[Docket No. FAA-2011-1115; Directorate Identifier 2010-SW-011-AD; Amendment 39-17017; AD 2012-08-01]

#### Airworthiness Directives; Sikorsky Aircraft Corporation Helicopters

**2012-08-01 Sikorsky Aircraft Corporation:**

Figure 1. Cat 'A' Takeoff and Landing Gross Weight

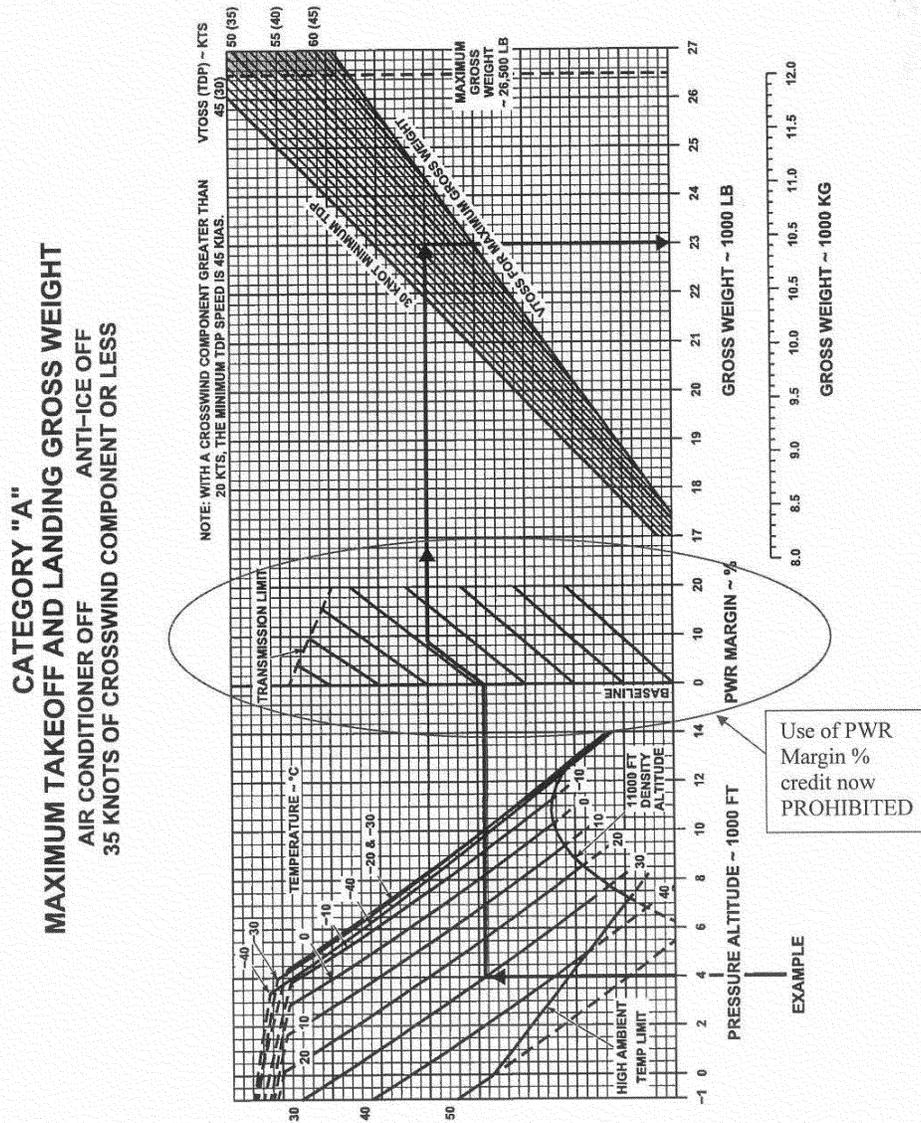
(2) If the RFM already contains the revisions appropriate for your helicopter as listed in the following Table 1, all dated April 9, 2008, with the correct performance charts, without the performance credit as depicted in the circled area of Figure 1 of this AD, the operating limitation required by paragraph (1) of this AD does not need to be inserted into the RFM.

**Note to paragraph (e)(2) of this AD:**  
Previous RFM revisions allowed for the use of above-specification engine power margin as depicted in the circled area of Figure 1 of this AD.

(1) By making pen and ink changes, insert into the Operating Limitations section, Part 1, Section 1, Weight Limits, of Rotorcraft Flight Manuals (RFMs) SA S92A-RFM-002, -003, -004, -005, and -006 the following limitation “Performance credit for above specification engine power margin is prohibited.”
